TO:	Darren Woolf	Neoscape	
FROM:	Peter Malinas	MGA Traffic	
DATE:	3 December 2019	OUR REF:	MGA19011
TITLE:	Piedimonte Supermarket Fitzroy North Response to Council RFI – Traffic Engineering

Piedimonte Supermarket Fitzroy North
Traffic Engineering Response to RFI

Piedimonte's Town Planning Application
Response to Council Referral Comments
Dec-19

CLIENT: PIEDIMONTE SUPERMARKET
PROJECT: 25-35 BEST STREET, NORTH FITZROY
CITY OF YARRA
TITLE: SWEEP PATH ASSESSMENT
LOADING DOCK
PIEDIMONTE LOADING VEHICLE (EGRESS)

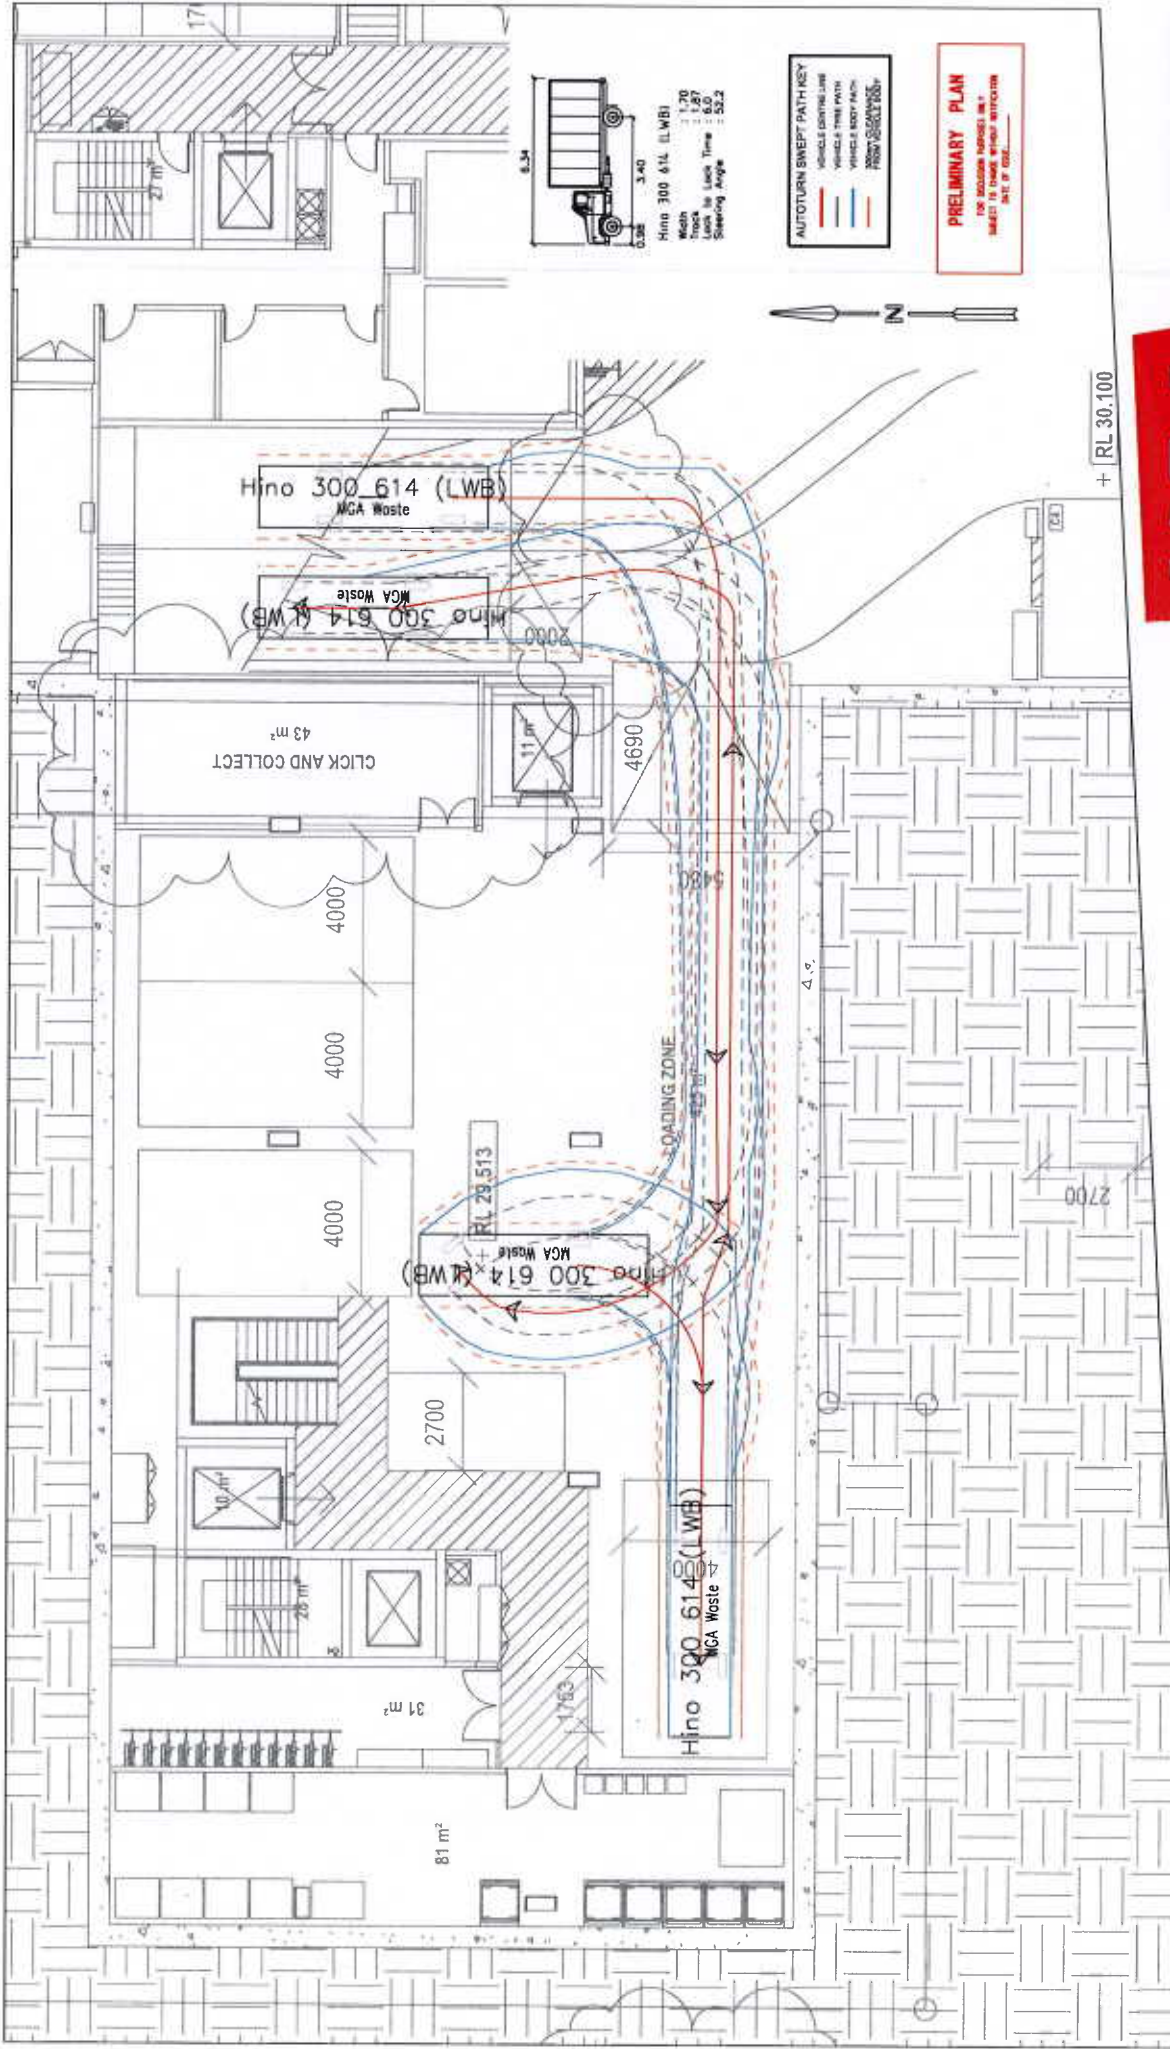
11	Loading Area Basement 01 Plan. Loading bays and aisle have not been dimensioned on the drawings.	The JCBA plans have been dimensioned.
12	Loading Area Swept Path Diagrams. The swept path diagrams for the waste collection vehicle and a van are considered satisfactory. The sizes of these vehicles have not been specified on the swept path diagrams.	The attached swept path diagrams have been updated. Refer to MGA19011-AT02 (for waste) and MGA19011-AT03 and AT04 (for vans).
13	Junction of Egremont Street and New East-West aligned Right of Way. Not provided.	The JCBA plans show the new east-west aligned ROW.
14	Number of Car Parking Spaces. Parking spaces have not been numbered, making identification difficult.	The JCBA plans show numbered spaces.
15	Road Safety Audit. It is strongly recommended that a Road Safety Audit of the development's Scotchmer Street road frontage (particularly at the entrance to the loading dock	The revised plans have incorporated several items to improve the safety of pedestrians around the loading dock, including convex mirrors and flashing lights. These measures would typically be recommended in a road safety audit. As such, it is

12	5	Civil Engineering Referral (29-Aug-19)	Loading Area Swept Path Diagrams. The swept path diagrams for the waste collection vehicle and a van are considered satisfactory. The sizes of these vehicles have not been specified on the swept path diagrams.	This has been addressed - refer to MGA Memo and draft amended plans.
13	5	Civil Engineering Referral (29-Aug-19)	Junction of Egremont Street and New East-West aligned Right of Way. Not provided.	This has been addressed - refer to MGA Memo and draft amended plans.
14	5	Civil Engineering Referral (29-Aug-19)	Number of Car Parking Spaces. Parking spaces have not been numbered, making identification difficult.	This has been addressed - refer to MGA Memo and draft amended plans.
15	6	Civil Engineering Referral (29-Aug-19)	Road Safety Audit. It is strongly recommended that a Road Safety Audit of the development's Scotchmer Street road frontage (particularly at the entrance to the loading dock and accessway) at the design phase be undertaken by an independent accredited Road Safety Auditor.	This has been addressed - refer to MGA Memo and draft amended plans.

DRAWING TITLE
SECTION AA
 DRAWING NUMBER
 A-TP3-100
 REVISION
 04

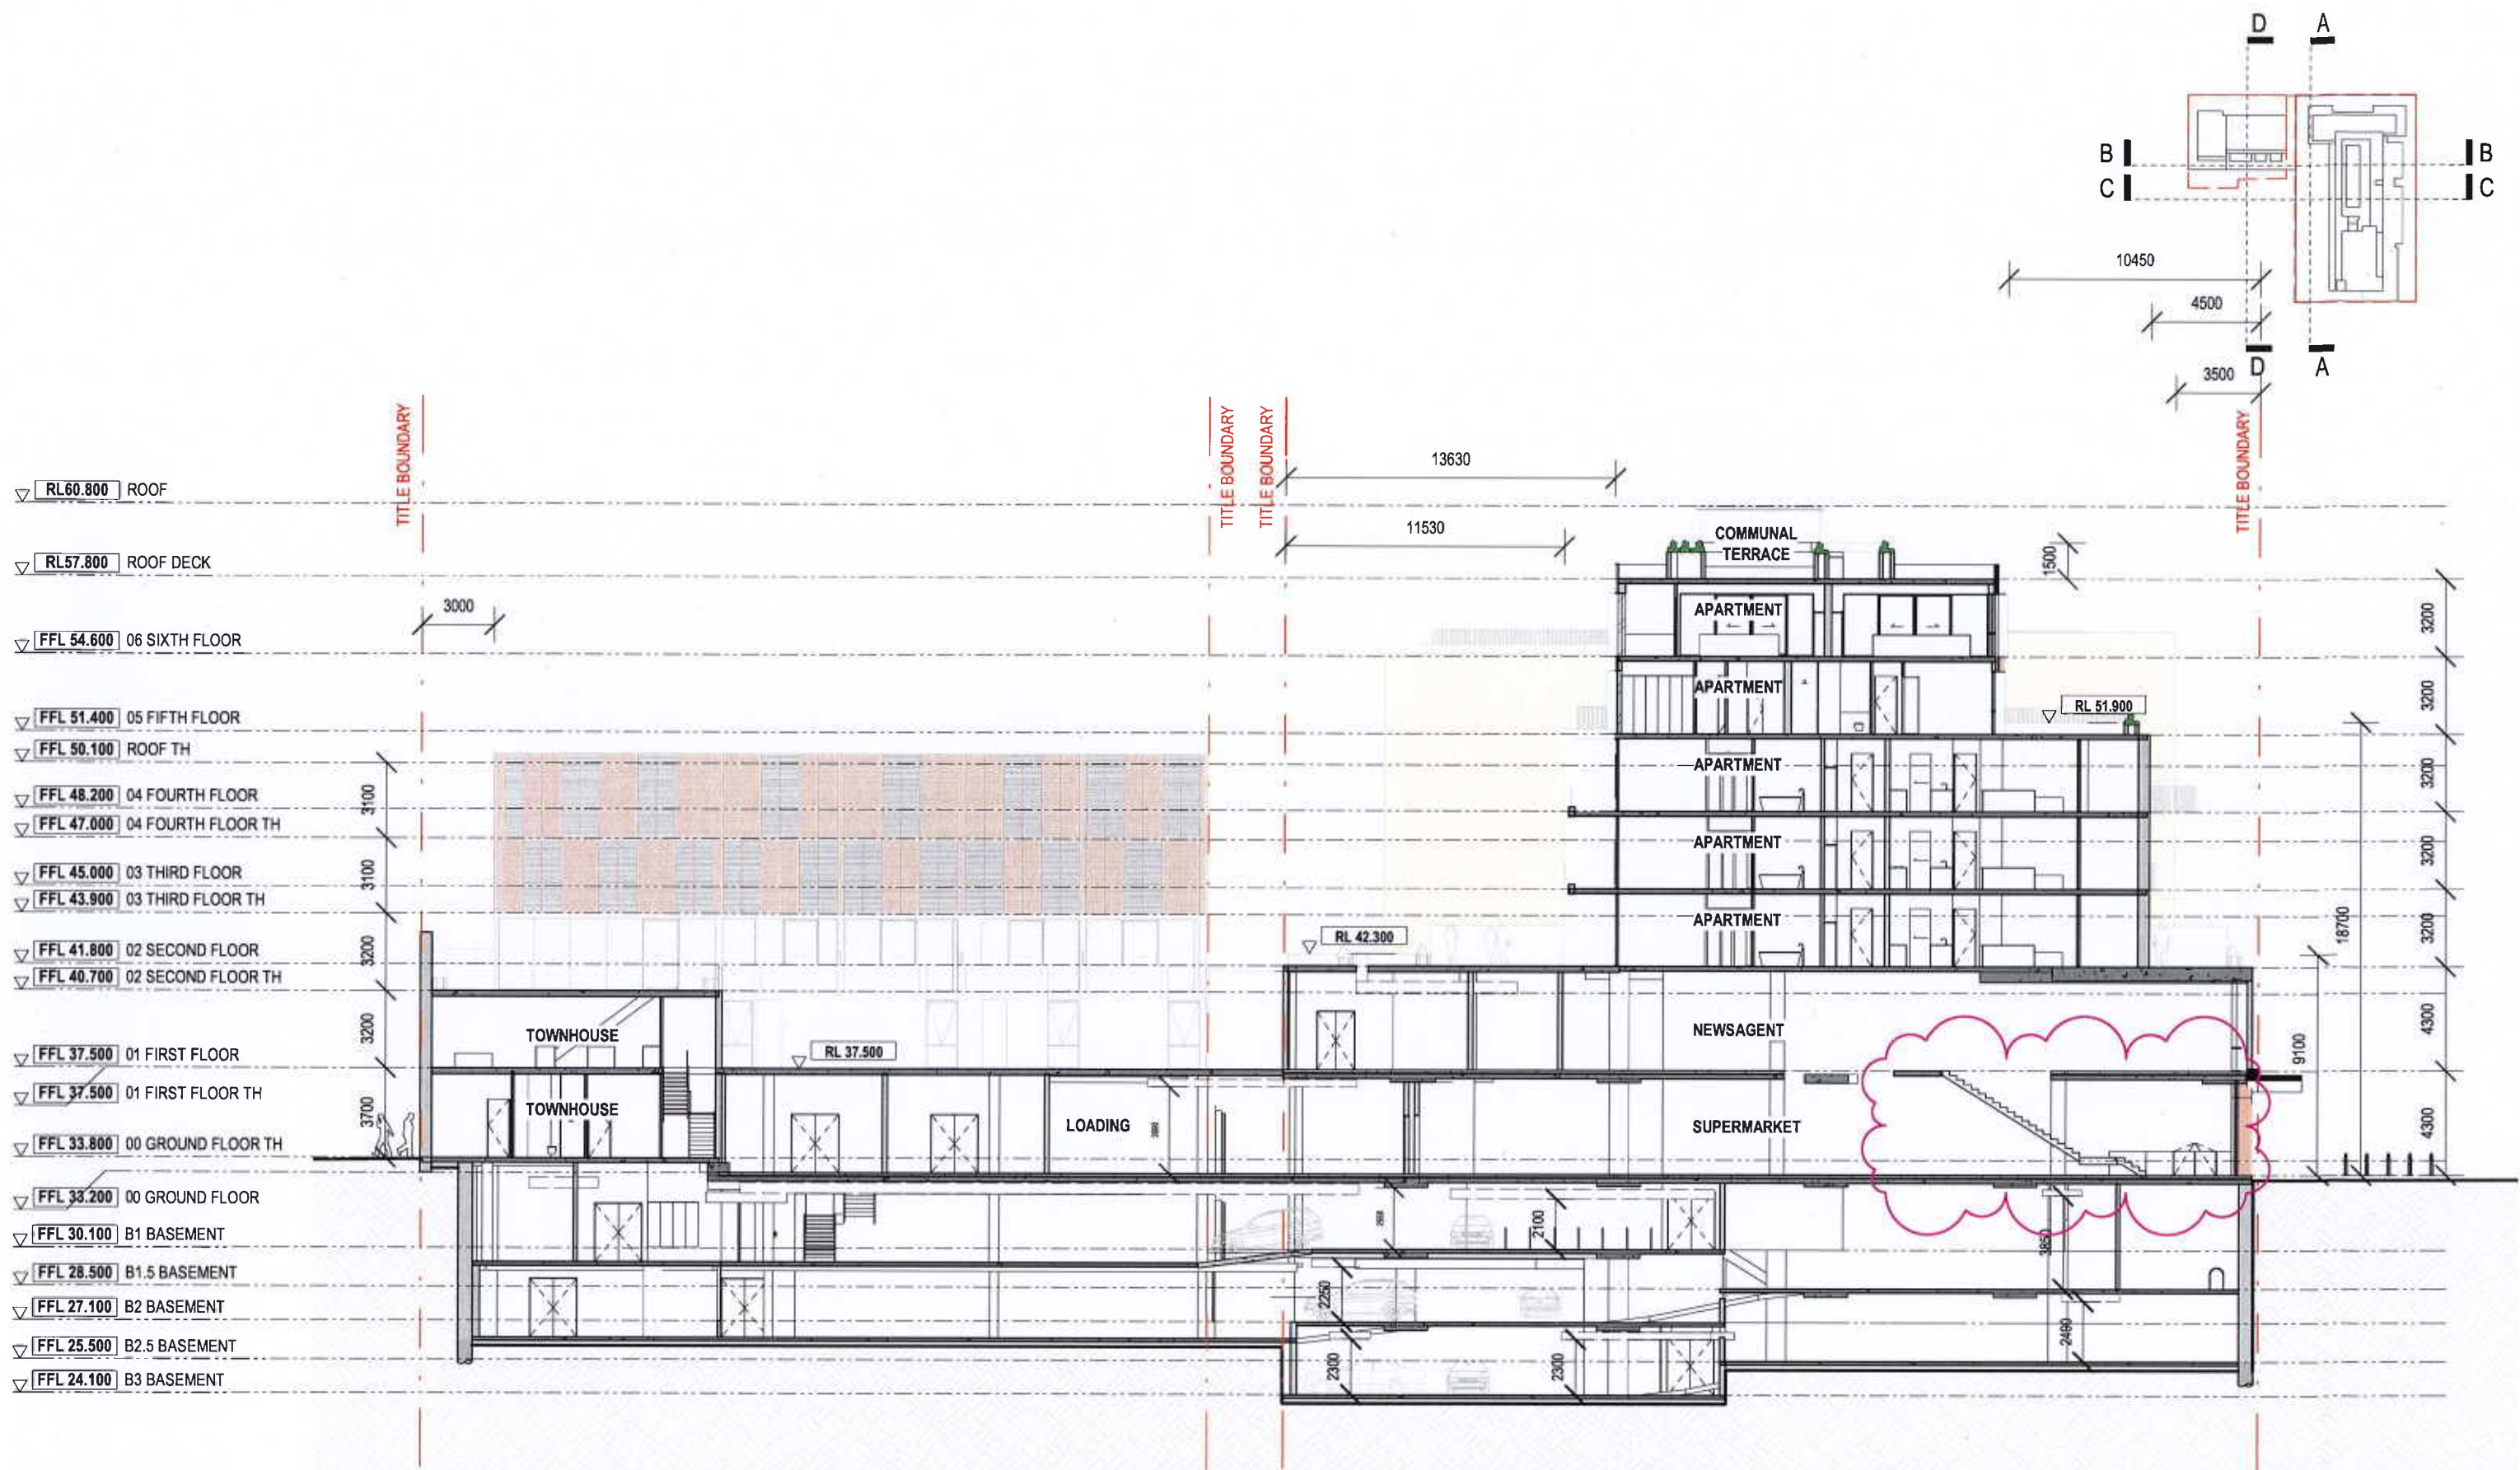
The below figure 3.2 demonstrates the head height clearance for vans going to Basement 1, at 2.5 meters high to allow for loading vehicles of maximum height 2.3 meters.

DRAWING NUMBER
A-TP1-100

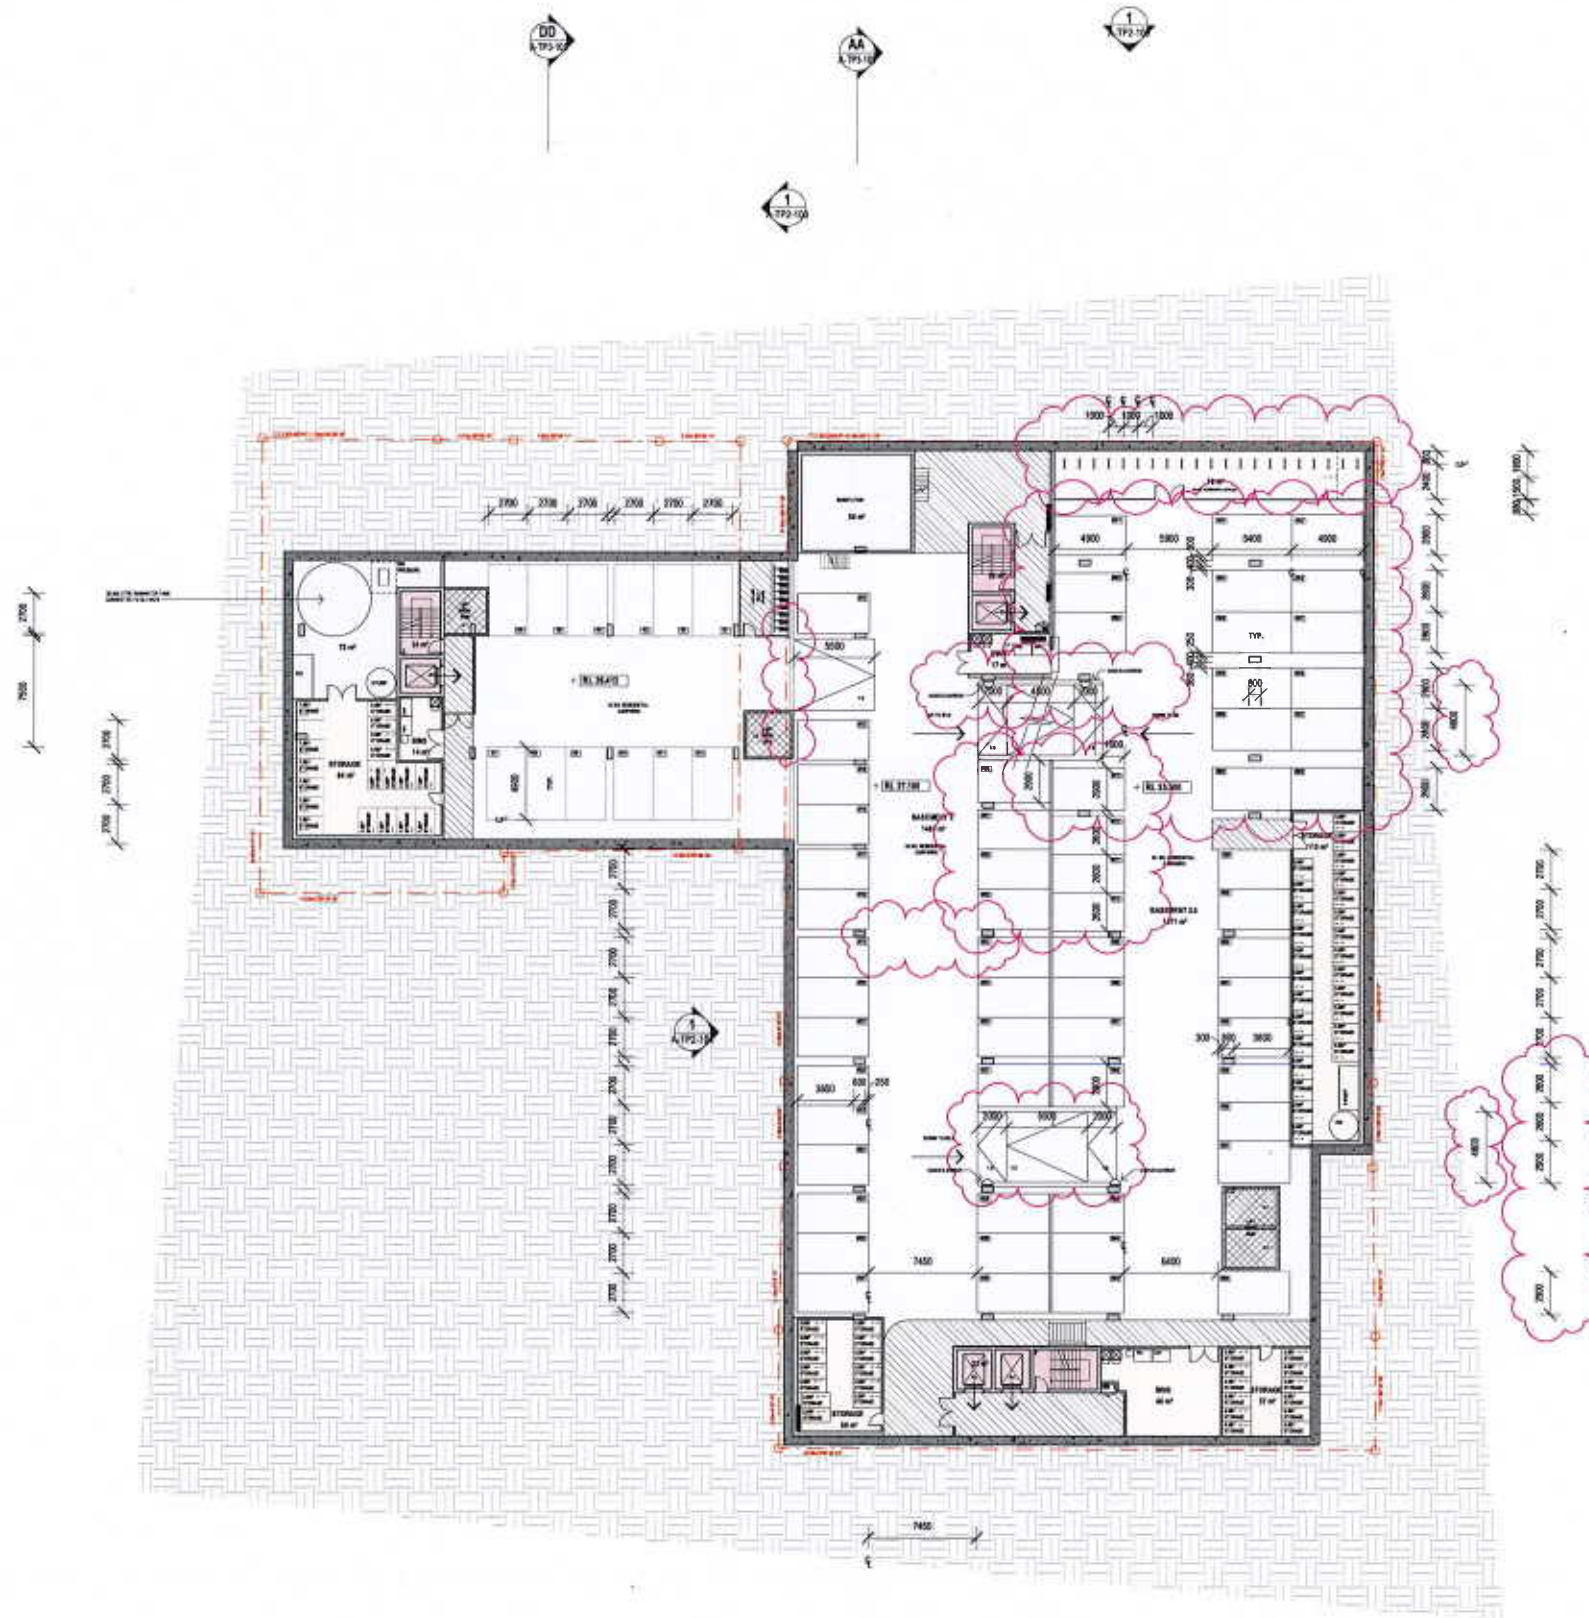
22	Electric Vehicles & Share Cars. The car share space is supported; however the bay should be relocated closer to one of the main lift shafts or entranceways.	As per the JCBA plans the car share space is located next to the lift core on basement 3. This is considered acceptable as it is allocated for resident use only.
23	Green Travel Plan. No Green Travel Plan (GTP) has been provided. Given the development has a total non-residential floor area of more than 1,000sqm, pursuant to Clause 22.17-4 a GTP must be provided.	It is understood that a green travel plans has been prepared by GIW.

Drawing Number	Itemized changes to each drawing
A-TP1-100	<ul style="list-style-type: none">• Car spaces numbered• Car share space moved closer to lift to reflect UD comments
A-TP1-101	<ul style="list-style-type: none">• Storage cage areas added, assigned to apartments• Ramp lengths dimensioned• Spaces adjacent to lift overruns dimensioned• Ramp to B1.5 removed as part of basement consolidation reflecting UD commentary• Bike parking areas secured with mesh walls/gates as required reflecting UD comments
A-TP1-102	<ul style="list-style-type: none">• Loading bays dimensioned• Ramp lengths dimensioned• Basement bike parking and EOT trip now co-located as part of supermarket parking consolidation to B1 and B1.5• Click and collect (online deliveries) storage area clarified• Loading dock red light added in line with traffic referral
A-TP1-103	<ul style="list-style-type: none">• Convex mirrors and flashing light added to loading area• Store paid line and entries amended to reflect UD comments• Lift access amended to reflect UD comments• Stair moved forward to improve Level 1 access and security in response to UD comments• Ramp dimensions added/highlighted
